# Access Compliance Report

## Public Rights-of-Way

### (Curb Ramps)

Intersection ID: 3817	Main Street: BROWNE'S_FERRY_RD	Cross Street: W_SUGAR_CREEK_RD	Location: NE
ADA ID: 7858B2C4660C	Ramp Type: Perp	Initial Pass/Fail: Fail	Overall Compliance: No
Severity Score: 12.5			
Codes/Mitigation Info/Possible Solution		Field Measurements/Component Compliance

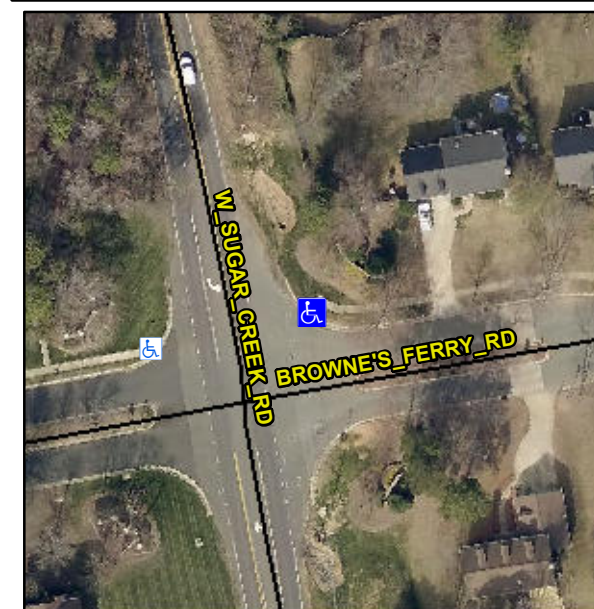
**Not Found, R304.2.2**

Compliance	Description	Data	Compliance	Description	Data
N/A	Ramp Length (in)	83.0	No	Ramp Slope (%)	9.7
Yes	Ramp Width (in)	48.0	Yes	Ramp XSlope (%)	0.7
N/A	Flare Type LT	N/A	N/A	Flare Type RT	N/A
N/A	Flare Slope LT (%)	N/A	N/A	Flare Slope RT (%)	N/A
N/A	Flare Traversable LT?	N/A	N/A	Flare Traversable RT?	N/A
N/A	Landing Length (in)	N/A	N/A	DWS Provided?	N/A
N/A	Landing Width (in)	N/A	N/A	DWS Contrast?	N/A
N/A	Landing Slope (%)	N/A	N/A	DWS Length (in)	N/A
N/A	Landing X Slope (%)	N/A	N/A	DWS Full Width?	N/A
N/A	Landing Curb? (Y/N)	N/A	N/A	DWS Offset (in)	N/A
N/A	Shared Landing?	N/A			
N/A	Gutter Ponding?	N/A	N/A	Gutter Slope (%)	N/A
N/A	Gutter Lip Ht (in)	N/A	N/A	Gutter X Slope (%)	N/A
N/A	Painted X Walk1?	No	N/A	Painted X Walk2?	N/A
	X Walk 1 Direction	To W		X Walk 2 Direction	N/A
N/A	X Walk 1 Width (in)	N/A	N/A	X Walk 2 Width (in)	N/A
	X Walk 1 Slope (%)	0.8		X Walk 2 Slope (%)	N/A
	X Walk 1 X Slope (%)	2.5		X Walk 2 X Slope (%)	N/A

**Remove & Replace Entire Ramp.**
